# Access Compliance Report

## Public Rights-of-Way

### (Curb Ramps)

Intersection ID: N/A	Main Street: FERNHILL_DR	Cross Street: GREEN_IVY_LN	Location: W
ADA ID: E034A4E53B23	Ramp Type: Perp	Initial Pass/Fail: Fail	Overall Compliance: No
Codes/Mitigation Info/Possible Solution		Field Measurements/Component Compliance	
Severity Score: 8.75

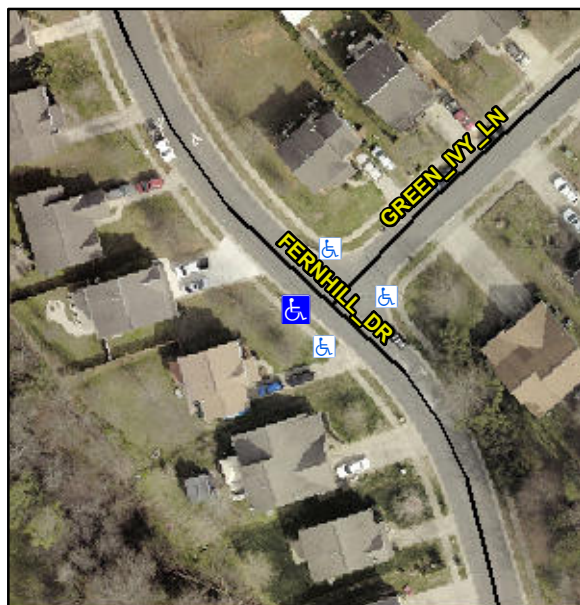
**Not Found, R304.5.1**

Compliance	Description	Data	Compliance	Description	Data
N/A	Ramp Length (in)	44.5	Yes	Ramp Slope (%)	7.0
No	Ramp Width (in)	47.5	Yes	Ramp XSlope (%)	2.0
N/A	Flare Type LT	N/A	N/A	Flare Type RT	N/A
N/A	Flare Slope LT (%)	N/A	N/A	Flare Slope RT (%)	N/A
N/A	Flare Traversable LT?	N/A	N/A	Flare Traversable RT?	N/A
N/A	Landing Length (in)	N/A	N/A	DWS Provided?	N/A
N/A	Landing Width (in)	N/A	N/A	DWS Contrast?	N/A
N/A	Landing Slope (%)	N/A	N/A	DWS Length (in)	N/A
N/A	Landing X Slope (%)	N/A	N/A	DWS Full Width?	N/A
N/A	Landing Curb? (Y/N)	N/A	N/A	DWS Offset (in)	N/A
N/A	Shared Landing?	N/A			
N/A	Gutter Ponding?	N/A	N/A	Gutter Slope (%)	N/A
N/A	Gutter Lip Ht (in)	N/A	N/A	Gutter X Slope (%)	N/A
N/A	Painted X Walk1?	No	N/A	Painted X Walk2?	N/A
	X Walk 1 Direction	To NE		X Walk 2 Direction	N/A
N/A	X Walk 1 Width (in)	N/A	N/A	X Walk 2 Width (in)	N/A
	X Walk 1 Slope (%)	3.4		X Walk 2 Slope (%)	N/A
	X Walk 1 X Slope (%)	1.5		X Walk 2 X Slope (%)	N/A

**Remove & Replace Entire Ramp.**
